SERVICE BULLETIN NO: 27-002

ATA CHAPTER: 27

FLIGHT CONTROLS - FLAPS INSPECTION OF THE LEAF SPRINGS IN THE FLAP OPERATING MECHANISM FOR CRACKS

Wing Strut Fittings - Inspection
Figure 1

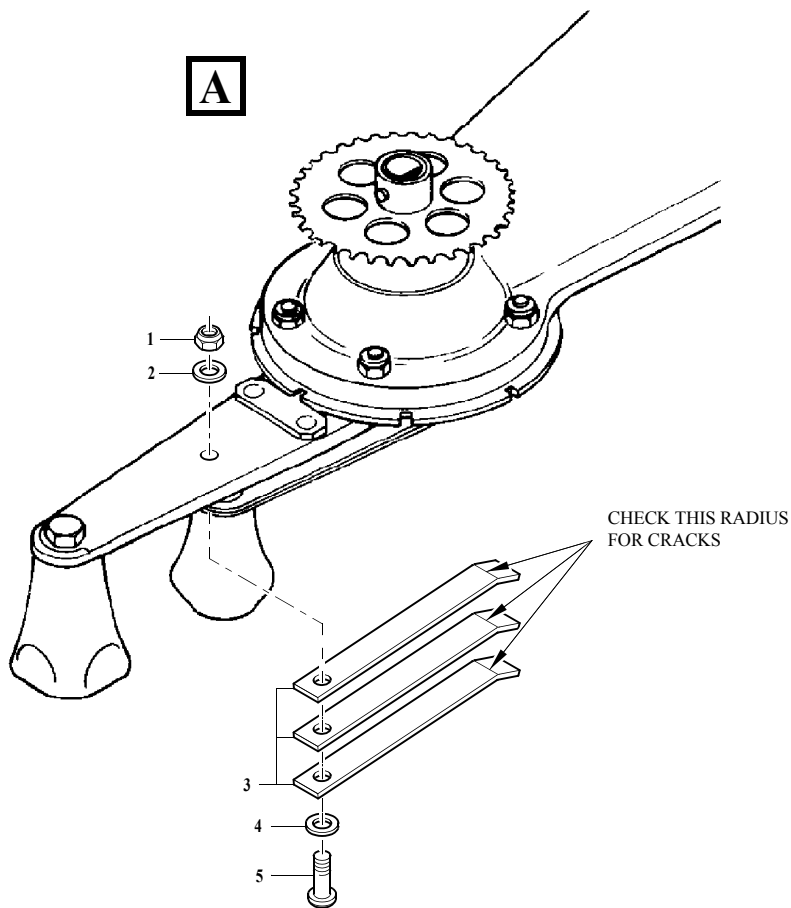
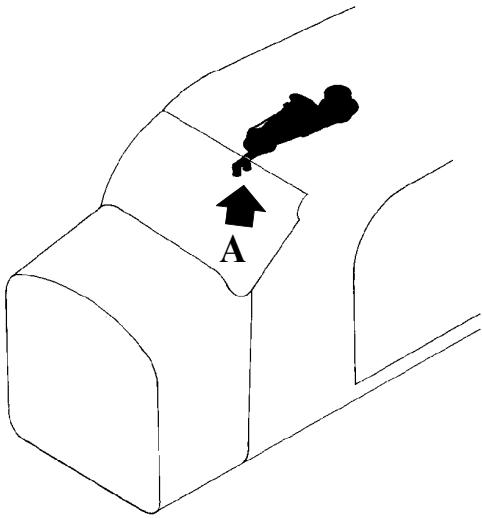
Before the next flight, and thereafter, every 25 flight hours, visually examine the radius of the leaf spring (3) for signs of cracks. Do this with a X10 magnifier and a source of bright light. No cracks are permitted. If you find a crack, you must replace the leaf spring before next flight.

Visually examine the radius of all leaf springs (3) P/N 6232.0175.01 held as spare or in stock for signs of cracks. Do this with a X10 magnifier and a source of bright light. No cracks are permitted. If you find a crack, return the leaf spring to Pilatus for replacement.

- (1) Remove the nut (1), the washers (2) and (4) and the screw (5).
- (2) Remove the three leaf springs (3).

- (1) Put the three leaf springs (3) in position.
- (2) Install the screw (5), the washers (4) and (2) and the nut (1).
- (3) Remove all tools and materials. Make sure that the work areas are clean.
